Access Compliance Report

Public Rights-of-Way (Curb Ramps)

Intersection ID: 43844	Main Street: CURRIER_RD	Cross Street: DELUCA_DR	Location: SW
ADA ID: 0DB7851A9C45	Ramp Type: BlendTrans1	Initial Pass/Fail: Pass	Overall Compliance: No
Severity Score: 7.75			
Codes/Mitigation Info/Possible Solution		Field Measurements/Component Compliance

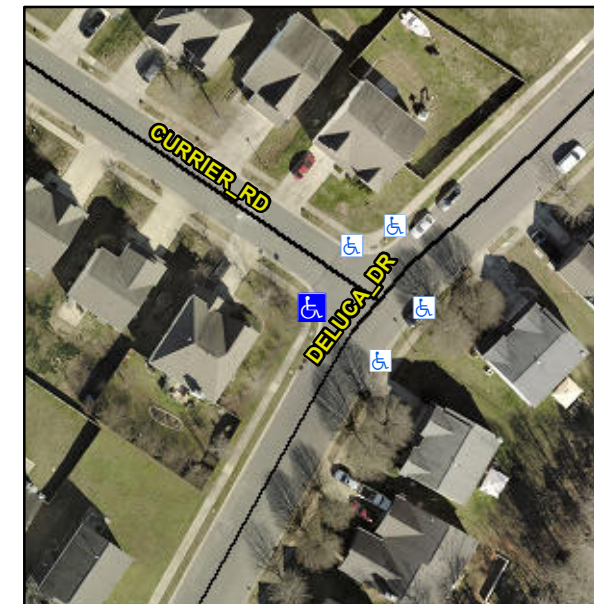
Not Found, R304.5.3, R304.2.1, R304.2.2-Perp, R304.3.2-Para, R305.1.4, R305.2, R304.5.4

Compliance	Description	Data	Compliance	Description	Data
N/A	Ramp Length (in)	46.5	Yes	BlendTrans Slope (%)	4.9
Yes	Ramp Width (in)	49.5	No	BlendTrans XSlope (%)	4.4
N/A	Flare Type LT	Sloped	N/A	Flare Type RT	Sloped
Yes	Flare Slope LT (%)	4.2	Yes	Flare Slope RT (%)	1.3
N/A	Flare Traversable LT?	Yes	N/A	Flare Traversable RT?	Yes
No	Landing Length (in)	47.5	Yes	DWS Provided?	Yes
Yes	Landing Width (in)	49.5	Yes	DWS Contrast?	Yes
No	Landing Slope (%)	5.2	Yes	DWS Length (in)	24.0
No	Landing X Slope (%)	4.7	No	DWS Full Width?	No
N/A	Landing Curb? (Y/N)	No	No	DWS Offset (in)	5.0
N/A	Shared Landing?	No			
Yes	Gutter Ponding?	No	No	Gutter Slope (%)	5.9
Yes	Gutter Lip Ht (in)	0.0	Yes	Gutter X Slope (%)	1.1
N/A	Painted X Walk1?	No	N/A	Painted X Walk2?	No
	X Walk 1 Direction	To SE		X Walk 2 Direction	To NE
	X Walk 1 Width (in)	N/A		X Walk 2 Width (in)	N/A
	X Walk 1 Slope (%)	1.1		X Walk 2 Slope (%)	1.6
	X Walk 1 X Slope (%)	7.7		X Walk 2 X Slope (%)	6.6

N/A	Ramp inside XWalk1?	N/A	N/A	Ramp inside XWalk2?	N/A
	Road Slope (%)	3.2		Clear Space?	Yes
	Road X Slope (%)	3.9	N/A	Clear Space to XWalk (in)	N/A
Yes	Any Obstructions?	No	Yes	Storm Grate/Utility Hazard?	No
	Obstruction Type			Storm Grate/Utility Type	
		N/A			N/A
			Yes	Surface Condition? (G/P)	Good
			No	Curb Slope (%)	18.2

Remove & Replace Curb Ramp With Two New Directional Ramps or Equivalent. Remove & Replace Gutter.
